# CITY OF ALBUQUERQUE

RE: **Drive Thru Restaurant** 700 Coors Blvd NW **Grading Plan Stamp Date: 8/15/19**

Hydrology File: J11D039

Based on the submittal received on 8/20/19, this project cannot be approved until the following corrections are made:

GD1.0

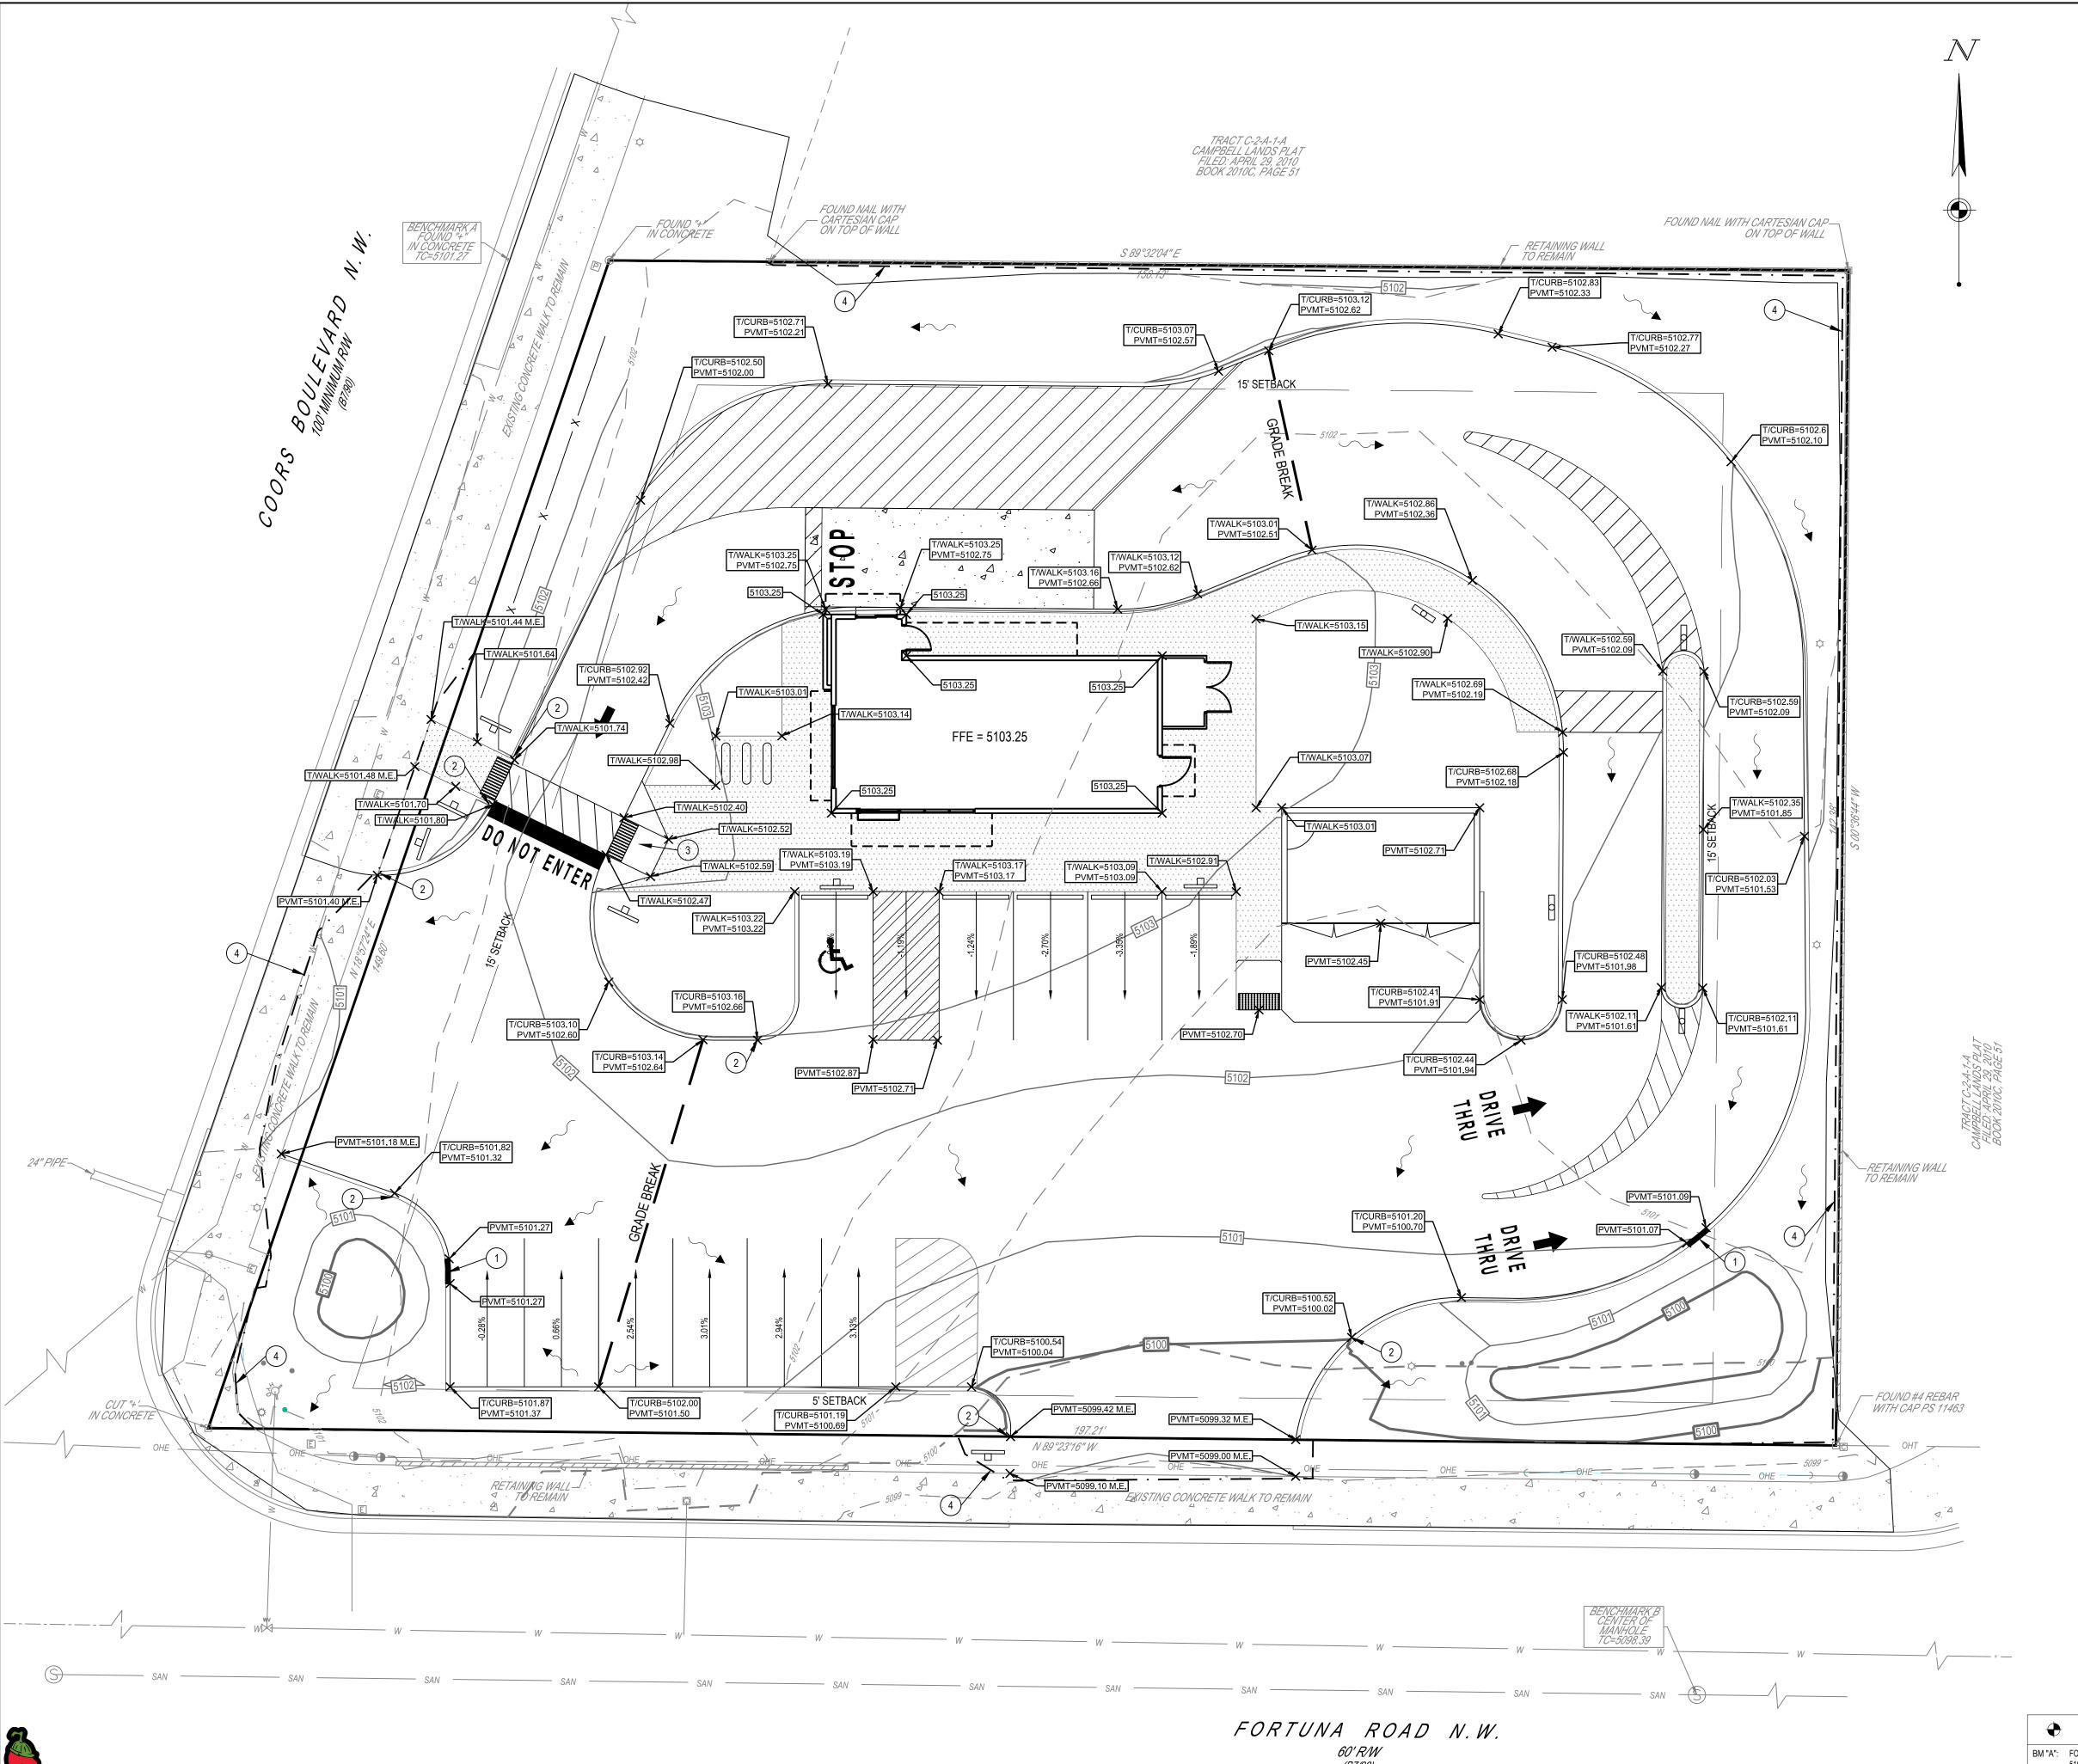
1. Runoff from impervious areas needs to be routed into the stormwater quality (SWQ) ponds. Please provide the SWQ volume calculations for each basin draining to each pond. The stormwater quality ponds need to be sized for the areas draining to them. It appears a large portion of the parking lot and roof simply flows out the driveway onto Fortuna.

3. Provide hydrologic calculations per the DPM, Ch 22.2.A for the 100-yr storm. Also, a brief narrative describing the project and existing/proposed grading and drainage is recommended (DPM Ch 22.7: Grading Plan Checklist).

- 4. Provide outfalls for both ponds, sized for the 100-yr peak inflow. Include supporting hydraulic calculations as needed.
- 5. It appears that your engineering stamp is too big. The NM Board of Licensure for Professional Engineers and Professional Surveyors Administrative Code 16.39.3.12.C states, "The design of the seal/stamp shall consist of three (3) concentric circles, the outermost circle being one (1) and one-half (1/2) inches in diameter...".
